Draft amendments to ECE/TRANS/WP.29/GRSP/2005/5/Rev.1
(Draft amendments to Regulation No. 16)

A. PROPOSAL

DESCRIPTION OF CURVE OF TROLLEY'S, DECELERATION OR ACCELERATION,
AS FUNCTION OF TIME

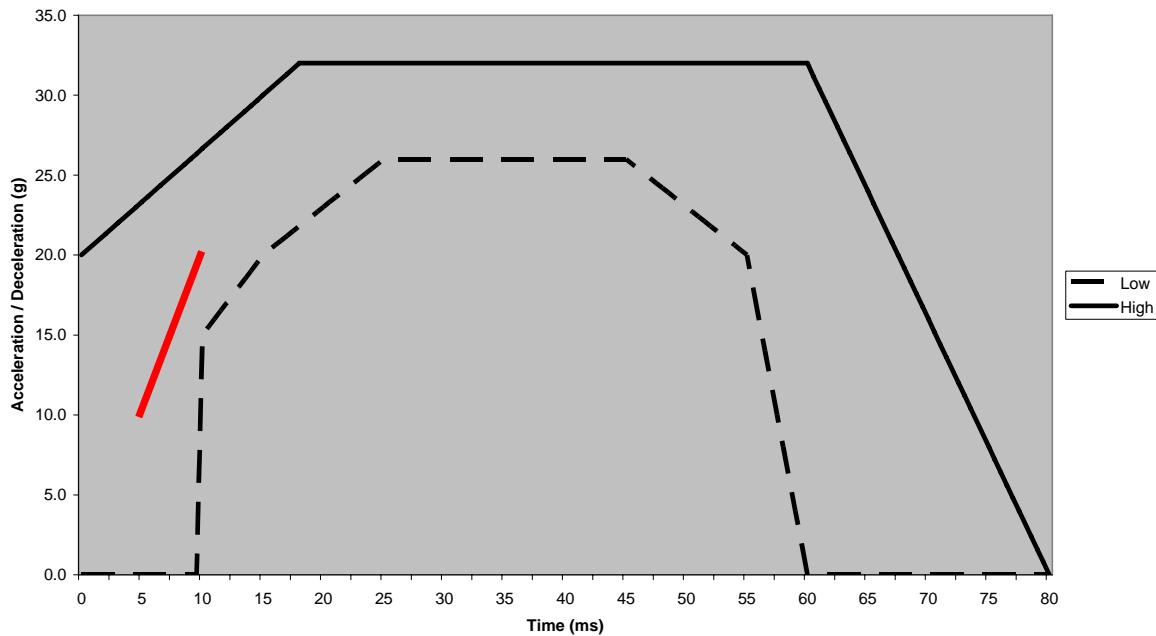
The acceleration curve of the trolley, weighted with inert mass, must remain within the hatched area of the graph in Annex 8, and stay above the segment defined by the coordinates 10g, 5ms and 20g, 10ms. The start of the impact (T0) is

Annex 8, amend to read:
